ECE411 PEER DESIGN REVIEW TEAM 8

TEAM 8:

TEAM 16:

SCHEMATIC NOTES:

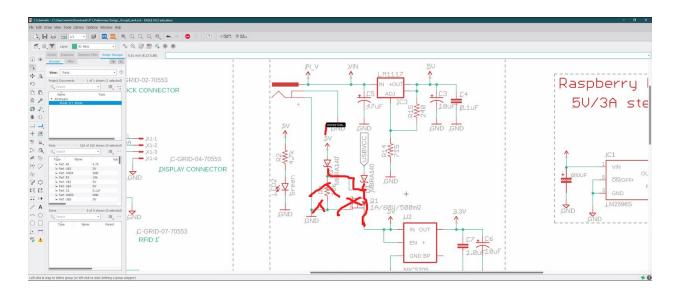
- Remove supply diode.
- Remove 3.3v supply for raspberry pi
- Usbvcc will explode usb chip
- Diode OR connections (5v supply and usbvcc)
- DC plug connect to ground pins 2 and 3
- 4.7k pull-up 5v for LCD I2C
- 1k resistor for LEDs
- 100nF capacitor connection to gnd from USB shield
- Remove Q1 and R4
- S1 Switch:

Having (1 and 2) connecting in parallel and (3 and 4) in parallel. Isn't this supposed to cause some issues?

- Solenoid lock and other sensors:
 Better to have them in separate blocks
- Having labels
 Better to connect with wires rather than labels
- AREF What is it? What does it do?

BOARD NOTES:

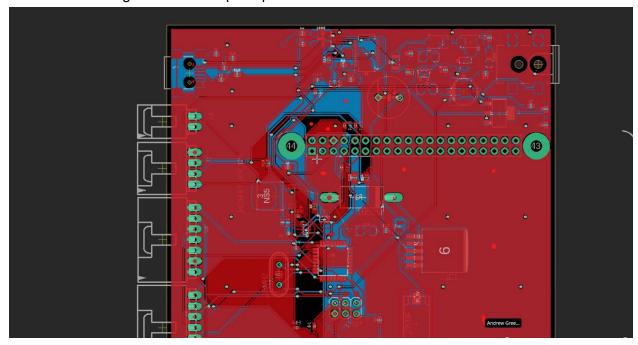
- More test points
- Gnd plane
- Test points
- Wider traces
- Board outline skewed
- Flood the gnd plane first
- Group switching power supply on board
- Thick lines on switching power supply
- Placement of mini usb
- Make the silk screen larger print
- Minimum trace size is 12mil for data lines and 50mil for power lines
- Add labels to test points
- Add more ground vias in open spaces

- Bigger SMD inductor
